Proposed Changes to the British Columbia Building Code 2024

Title: National Building Code Secondary Suites

Subject/description: Proposal to primarily accept the smoke-tight barrier solution for secondary suites from the model National Building Code (NBC) as an additional option in the British Columbia Building Code (BCBC).

Applicable Code references: Part 9 of Division B

[Figure A-1.4.1.2.\(1\)-C2](#)
[Row House Building Types with Secondary Suites](#)

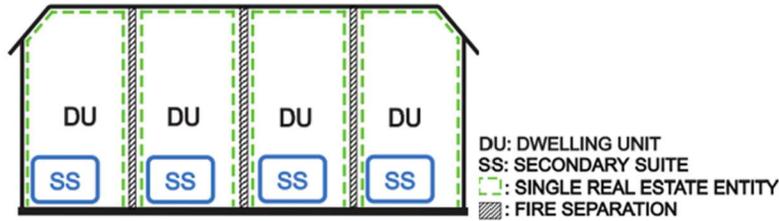
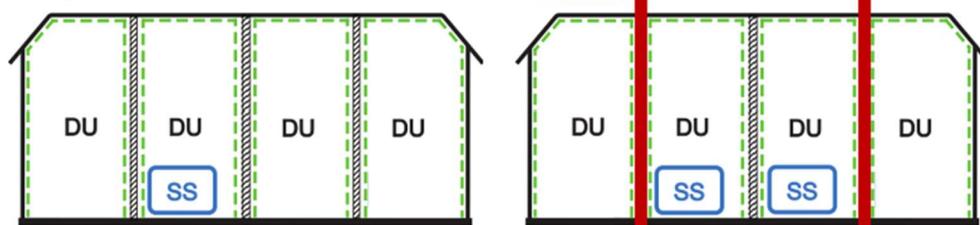
[See Figure A-1.4.1.2.\(1\)-C2 for row house building types with secondary suites with fire separations and secondary suites with smoke-tight barriers in lieu of fire separations within houses.](#)

British Columbia Building Code permits every rowhouse to have a secondary suite

National Building Code permits a rowhouse to have a secondary suite, **BUT** if an adjacent house wants to add a secondary suite then **firewalls** must be added

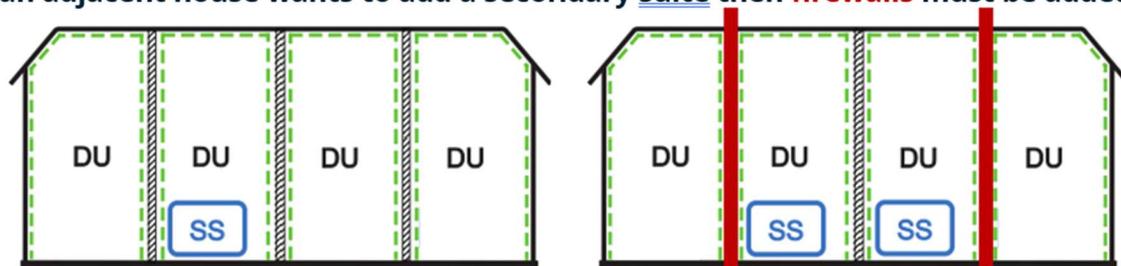
For some building types however, such as row houses, the option to use the NBC’s smoke-tight barriers should be carefully considered as there are requirements for the building as a whole that must be met. If two adjacent houses of a rowhouse have secondary suites constructed using smoke-tight barriers, then those two houses must be separated from the remainder of the houses in the building with firewalls.

British Columbia Building Code permits every rowhouse to have a secondary suite

National Building Code permits a rowhouse to have a secondary suite, *BUT* if an adjacent house wants to add a secondary suite then **firewalls must be added**

Owners of rowhouse units may have an interest should a secondary suite project be proposed for adjacent units as there may be some coordination required should they also wish to add a secondary suite. Installation of firewalls to an existing building would be a proportionately large and costly project and should be coordinated with all owners of the rowhouse units. For secondary suite projects in rowhouses, the BCBC option remains available.
